Responses to Information Request 10

IR 10 – Groundwater Interactions between Fish Lake and Open Pit.

PROJECT: NEW PROSPERITY GOLD-COPPER PROJECT

Figure 10B-1. Pumping Test #1: Pumping Well Drawdown (KP 1995)

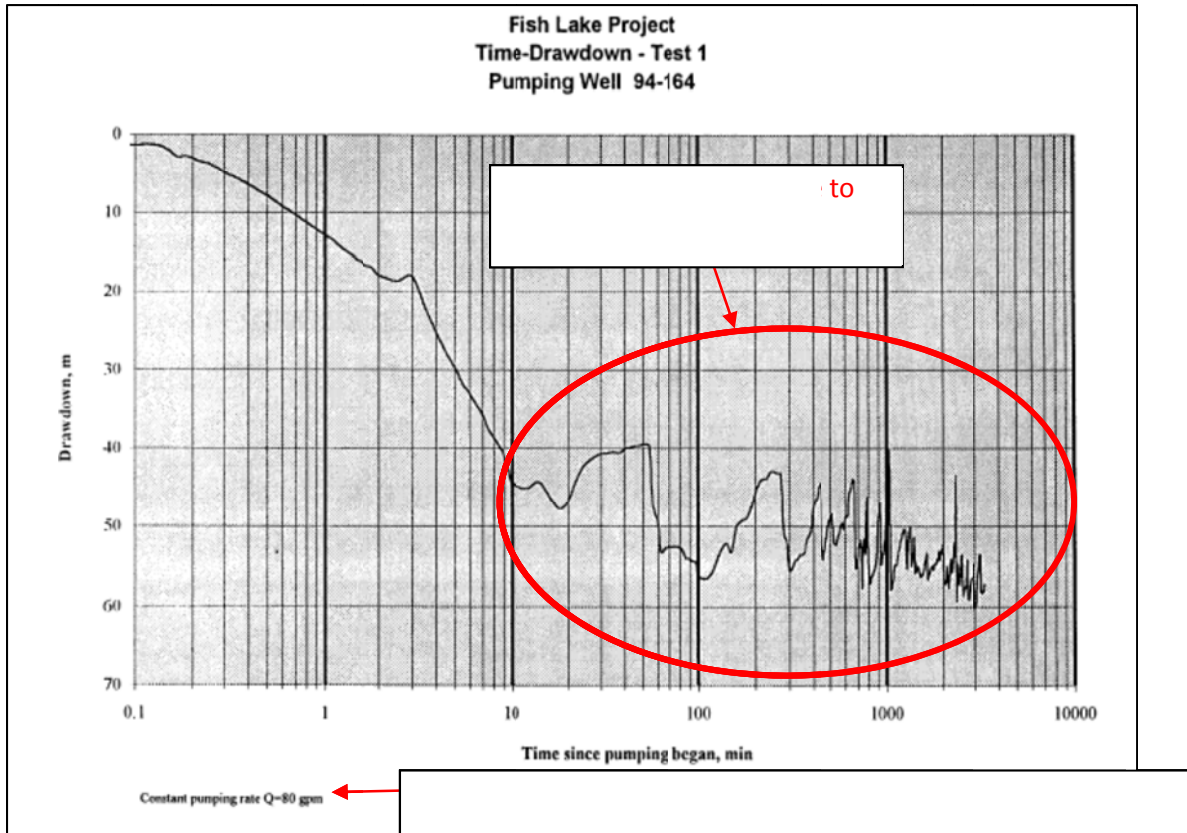
Provide further rationale why the pump test data from wells 94-154, 94-157 and 94-159 were not relied on by BGC Engineering and were not used for the purposes of the Baseline Groundwater Hydrology Assessment (Appendix 2.6.1 4D-A).

- 2) The pumping rate was not recorded throughout the test duration, and the observed pumping water levels suggest that a steady state pumping condition was not achieved, as shown on Figure 10B-1.

Based on BGC's experience, the drawdown fluctuations observed in this test are likely due to fluctuations in the pumping rate. This can often happen in lower producing wells if the test pump is not constantly adjusted for the declining water level in the pumping well. As pumping test analysis methods generally rely on the assumption of a constant pumping rate, the results obtained from these tests are uncertain.

The pumping well drawdown plot indicates that during the pumping test the well water level was around 60 mbgl. BGC has attributed the fluctuations in drawdown to fluctuations in the reported pumping rate of 80 USgpm. Based on BGC's experience conducting pumping tests with similarly constructed bedrock wells, they estimate the pumping rate could have fluctuated between as low as 20 USgpm (4 times less than the reported rate) and as high as 160 USgpm (2 times higher than the reported rate). It is unlikely that the well pumping rate was much higher than 160 USgpm, as that would be a much higher pumping rate than the capability of a submersible pump which could fit in the 168 mm well.
